## COUNCIL ASSESSMENT REPORT

### SYDNEY EASTERN CITY PLANNING PANEL

| <b>PANEL REFERENCE &amp; DA NUMBER</b>                                      | PPSSEC-295 – DA2023.79                                                                                                                                                                                                                                                                                                                                                                                                                                                                                                                                             |
| <b>PROPOSAL</b>                                                             | Demolition of the existing building and construction of an 18 storey mixed use development containing 49 residential units, 9 serviced apartments, 9 commercial tenancies and 2 retail tenancies, above basement parking and landscaping and site works.

**Figure 14:** Extract of the 12pm sun-eye diagram illustrating No. 4 Railway Parade in blue

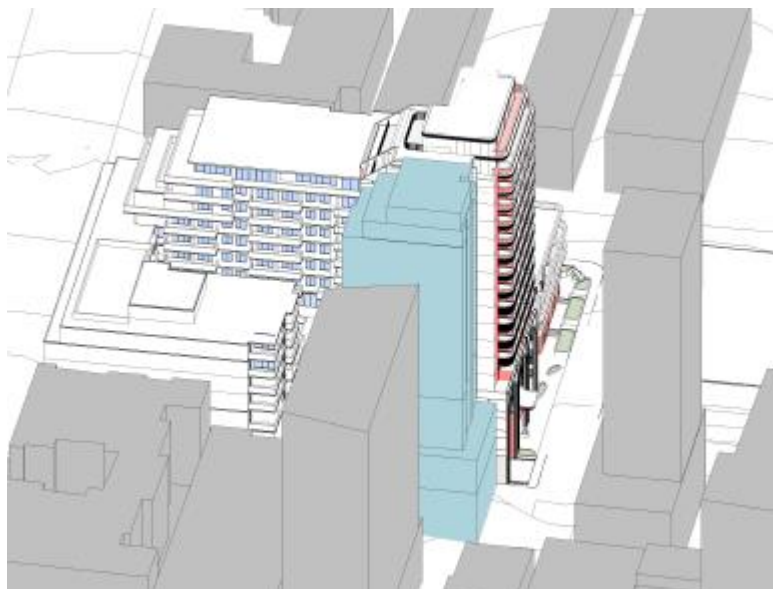
The design criteria of Objective 3D-1 also require the principal usable part of the communal open space to achieve a minimum of 2 hours of solar access between 9am and 3pm on June 21.

The communal open space is located on the southern side of the podium on Level 4 as a single consolidated space. This area of the building will be overshadowed by the approved boarding house on No. 4 Railway Parade to the north of the site. The approved massing is illustrated in the sun-eye diagram extract below and the photomontage in Figure 12 earlier in the report.

**Figure 15:** Extract of the 1pm sun-eye diagram illustrating 1-3 Elizabeth Street overshadowing the podium

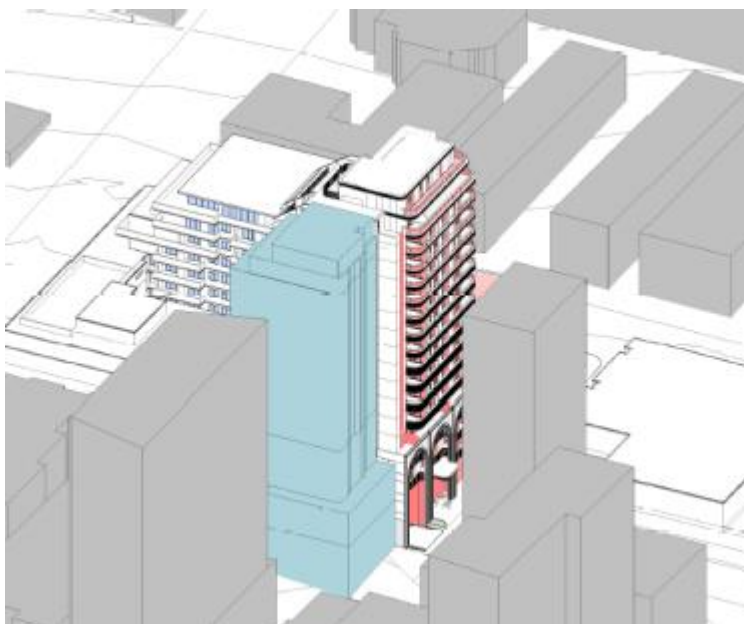
The podium area is also partly overshadowed by the built development at 1-3 Elizabeth Street to the northwest. Refer to the extract of the 1pm sun-eye diagram below.

Concern over the solar amenity to the communal open space was raised to the applicant by the DRP and in the initial request for additional information. The applicant responded that a relocation or supplementary provision of the communal open space to the rooftop would encounter difficulties in accommodating a suitable size given the modest footprint of the tower portion of the building. Further, the applicant articulated the challenge in complying with Clause 4.3A of the LEP which prescribes a maximum building height plane.

**Figure 16:** Extract of the communal open space solar access (PTW Architects)

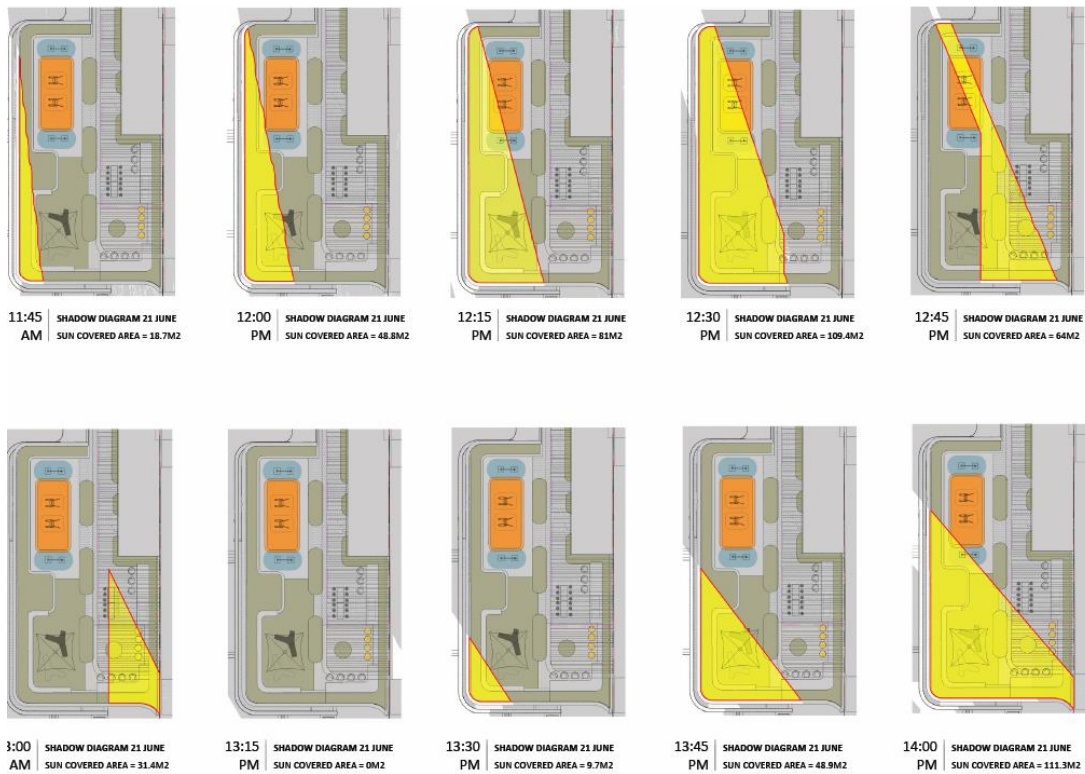
The submission of additional information by the applicant reinforced the optimal location for the communal open space was the larger podium area. Further, solar access diagram information was provided to illustrate the amount of solar access available at mid-winter. Refer to Figures 14 and 15 below. The extracts illustrate the level of solar access available to the communal open space from 11:45am (when it starts receiving solar access) until 4pm.

**Figure 19:** Comparison between the submitted and revised Unit .03 typology layouts

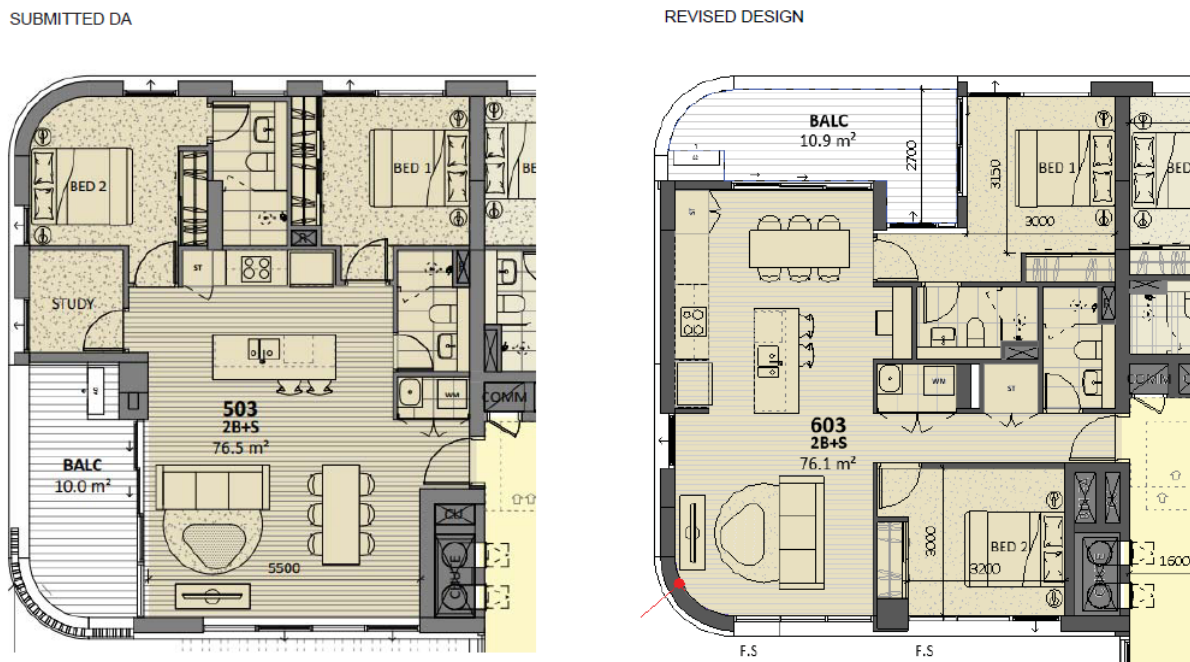
The planning of the southern unit has been revised through the assessment to deliver an improved visual privacy outcome. Refer to the floor plan comparison below in Figure 19. The original design proposed the balcony (with privacy screens) in the southeastern corner which interfaces with 1-3 Belmore Street. The revised design has improved solar access to this unit by relocating the balcony to the west elevation but has resolved a visual privacy concern by creating a blank wall at the corner.

**Figure 20:** Sightline analysis from Unit 503

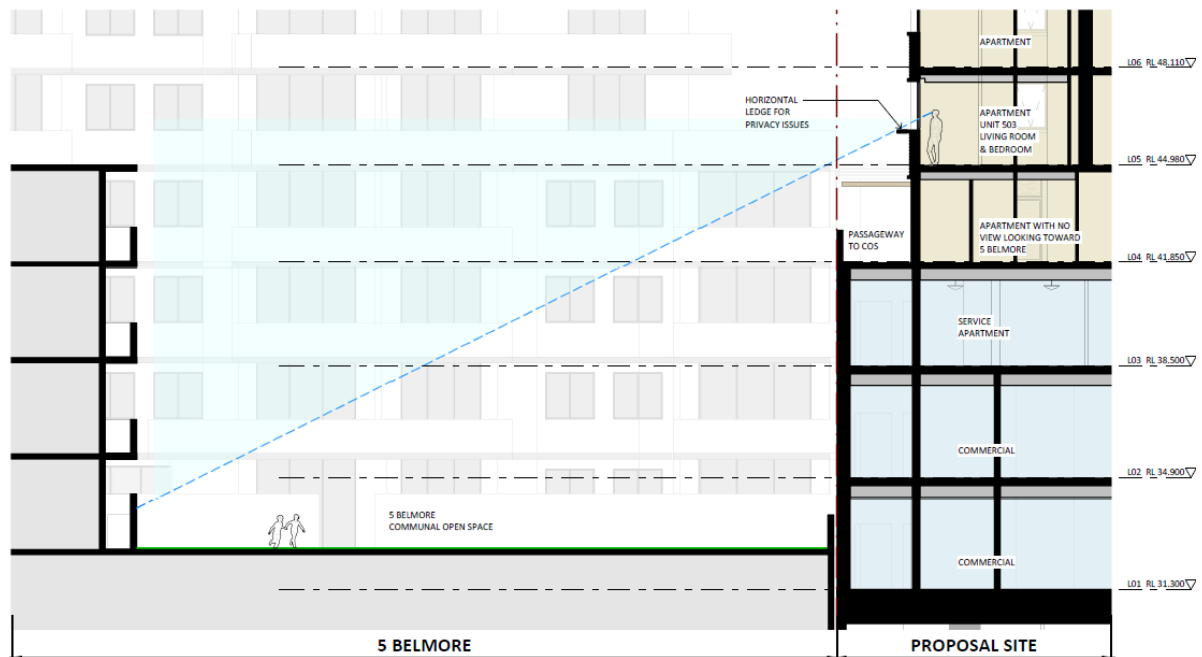
For the same unit type, the eastern windows (shown on the bottom of the above floor plans) also face 1-3 Belmore Street over their northern setback. These windows are only 2.6m from the boundary and thus within the building separation. One of the two communal open spaces for 1-3 Belmore Street is situated within the northern setback. A downward sightline from the Unit 503 window could overlook the open space. A request of the applicant was made to provide a sightline analysis to determine if privacy measures were warranted. The sightline analysis in Figure 20 was produced.

A horizontal ledge was introduced below the two windows to prevent the downward view angle to the communal open space of 1-3 Belmore Street. A direct view over the communal space to the eastern portion of 1-3 Belmore Street exceeds 24m and is compliant with the building separation.

**Figure 21:** Extract of 8am to 11am sun-eye diagrams

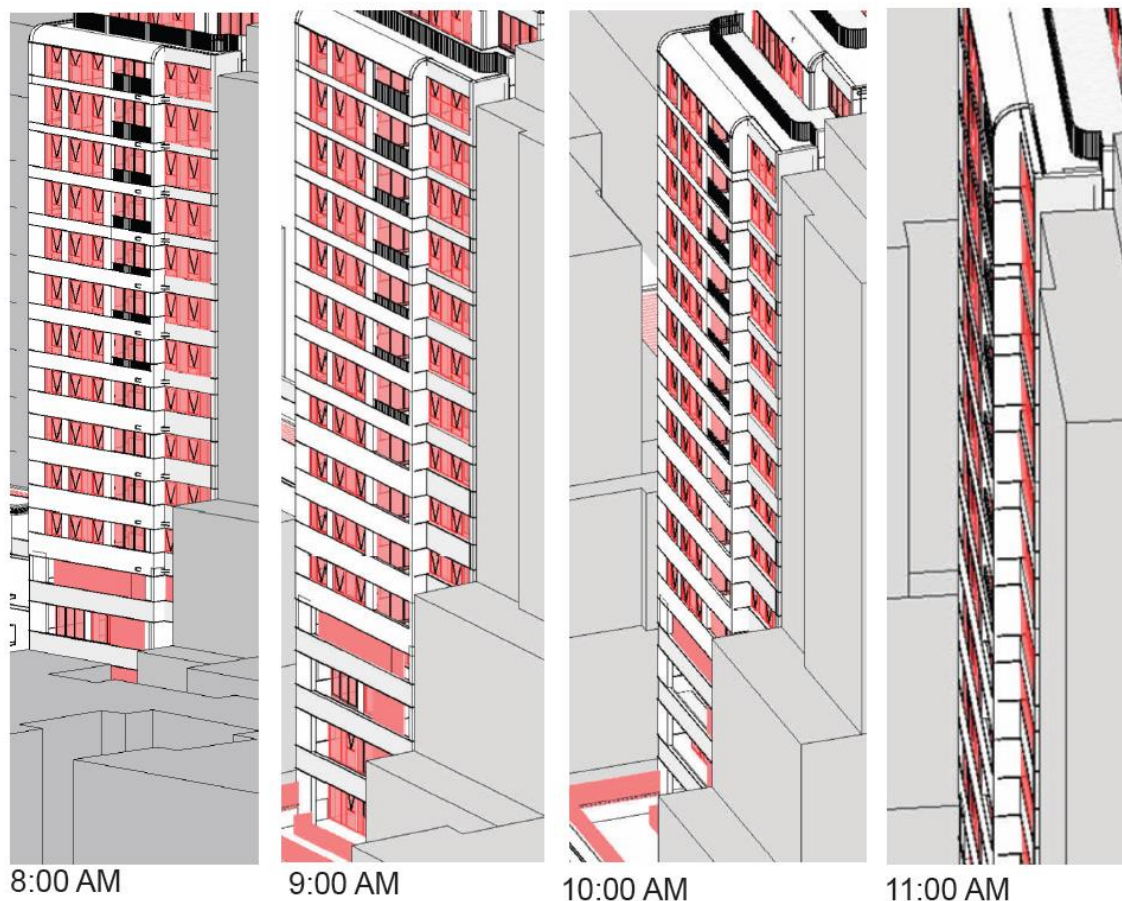
The applicant has claimed 35 units (71%) achieve 2 hours of solar access. However, based on the sun-eye diagrams submitted, it is not likely that solar access to units at 11am achieves the design guidance which states “to maximise the benefit to residents of direct sunlight within living rooms and private open spaces, a minimum of 1m<sup>2</sup> of direct sunlight, measured at 1m above floor level, is achieved for at least 15 minutes.” The 9am to 11am sun-eye diagrams as relevant to the eastern elevation of the building are illustrated below.

The eastern elevation does receive solar access at 8am (see Figure 21), ensuring a complete 2 hours at the minimum between 8am and 10am. While 8am is not part of technical compliance, it does demonstrate that meaningful sunlight and natural light will be still available to these units. Further, all living rooms and private open spaces enjoy east and west orientations and there are no single aspect south facing units. Glazing is proposed in good proportions to maximise natural light.

**Figure 24:** Comparison between the submitted and revised Unit 503 typology layouts

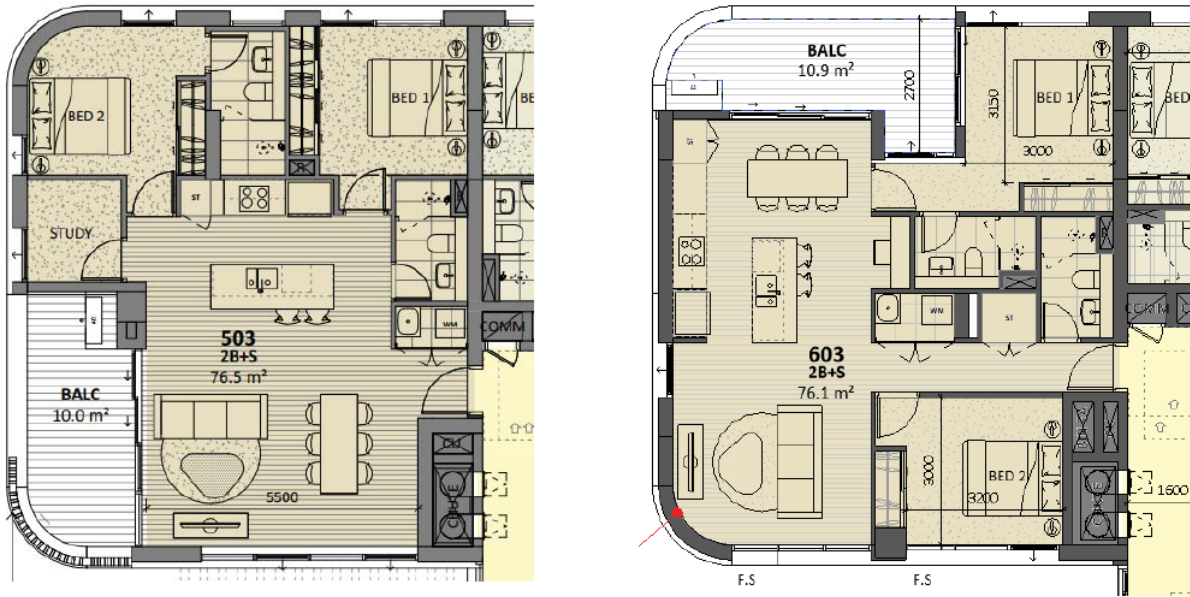
The applicant explained their unit design philosophy for Unit 503 was to create opportunities for views to the east toward the city. However, in recognition of the non-compliance to solar access and the aforementioned court decision, a revised unit layout was prepared. A comparison between the submitted and revised design is provided below.

The original design proposed both the balcony and living room solely on the eastern side of the site. As mentioned, the unit would receive no solar access in the AM as it is set behind Unit 502 which extends further east. The units do, however, receive some solar access in the afternoon, including 2 hours of solar access to private open spaces on Levels 13 and above. The redesigned unit takes advantage of this by relocating the private open space to the western elevation and reconfiguring the living room to capture both the desired views to the east and connect to the balcony to the west.

**Figure 29:** Height Blanket (Source: Drawing No. PTW-DA-Q12C010)

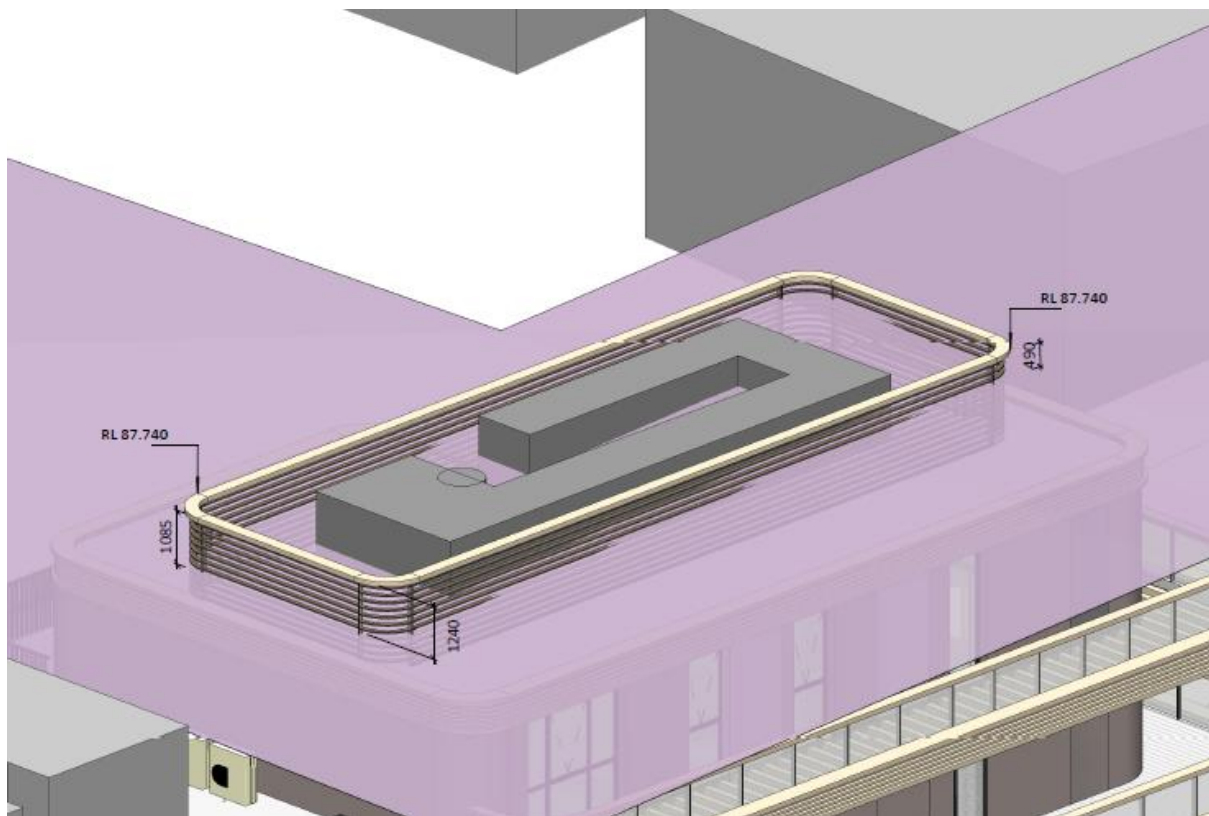
The extent of the variation is 1.24m (2%) and is limited to mechanical plant and the screening used to conceal these elements. Refer to the building height plane diagram below.

It is not agreed that the screening around the perimeter of the mechanical plant constitutes an architectural roof feature. Clause 5.6 does not specifically define an architectural roof feature but it does provide some guidance under 5.6(3):

**Figure 31:** Applicant's massing study

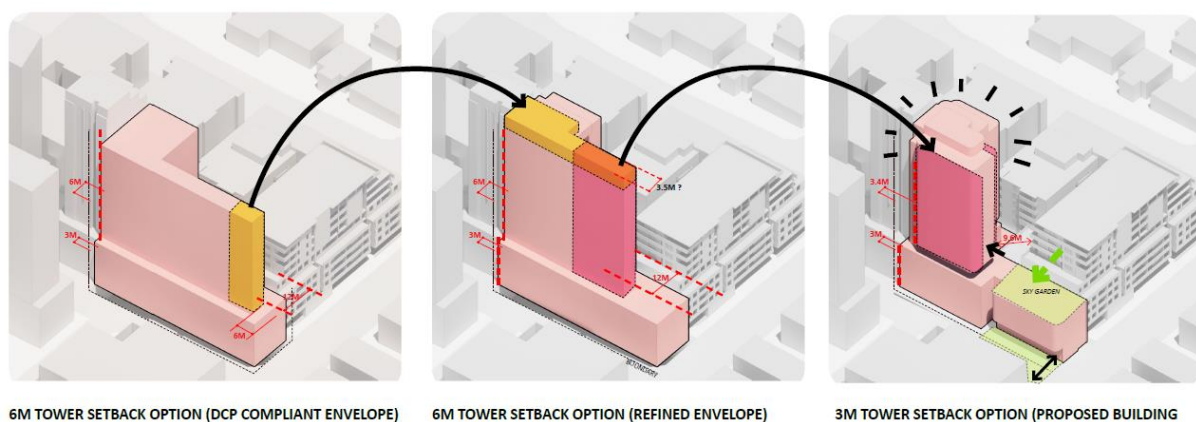
A 6m secondary street setback for the tower portion of the building is prescribed in Figure 28. The proposal provides for a 3.4m minimum setback.

A strictly compliant 6m secondary street setback would leave a tower width of approximately 3.5m once a setback to the east was also considered. A nil setback to the east (and the

**Figure 32:** Waste Collection Area and Pedestrian Route

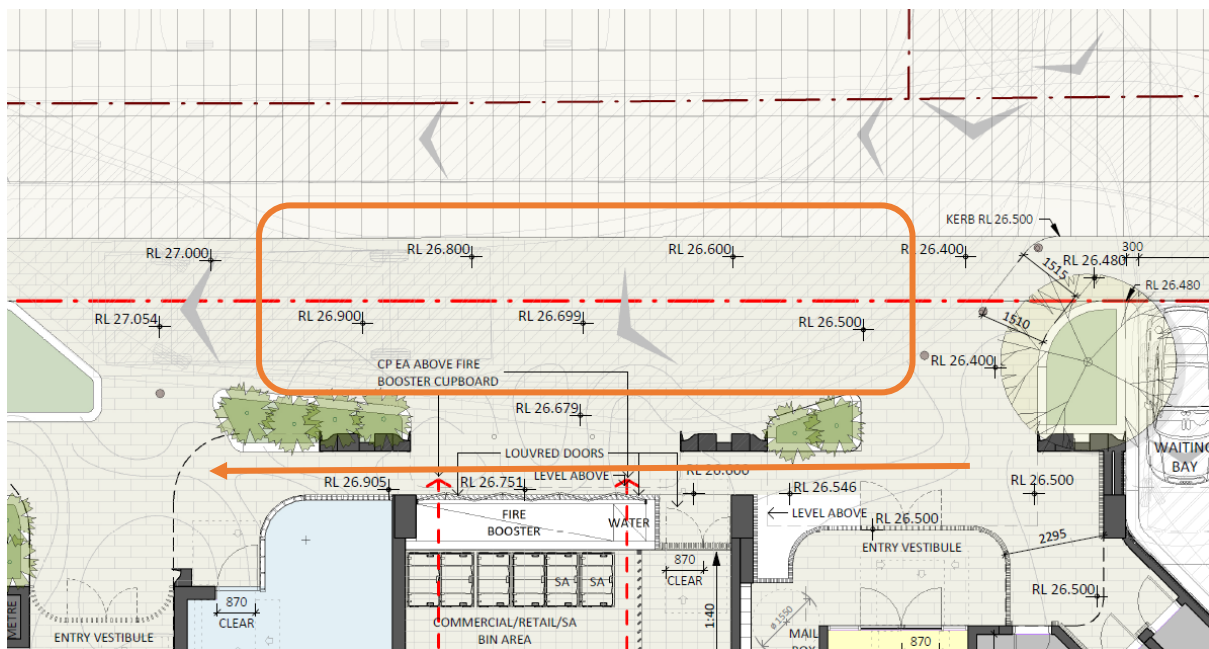
The initial submission sought for waste collection to occur at ground level and within the setback area of the site. No dedicated 'loading bay' was proposed within the building envelope. The location of the waste collection area is illustrated below.

The initial referral from Council's Traffic and Waste officers raised concerns over the waste collection location. The main concerns raised were:

**Figure 38:** Communal open space impact assessment

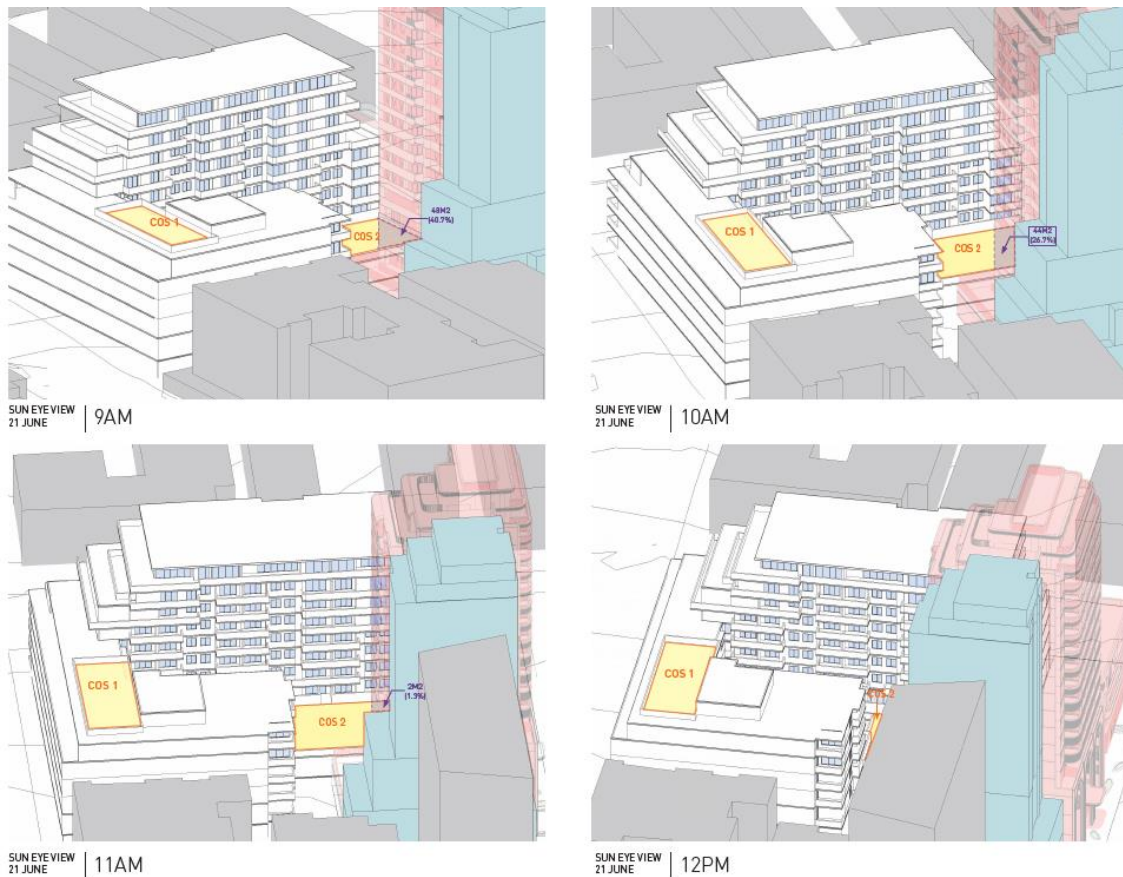
The assessment showed that 2 hours of solar access would continue to be achieved to the lower communal open space between 9am and 11am, though the extent would be reduced particularly at 9am. Notwithstanding this, the impact is acceptable in that 2 hours is maintained.
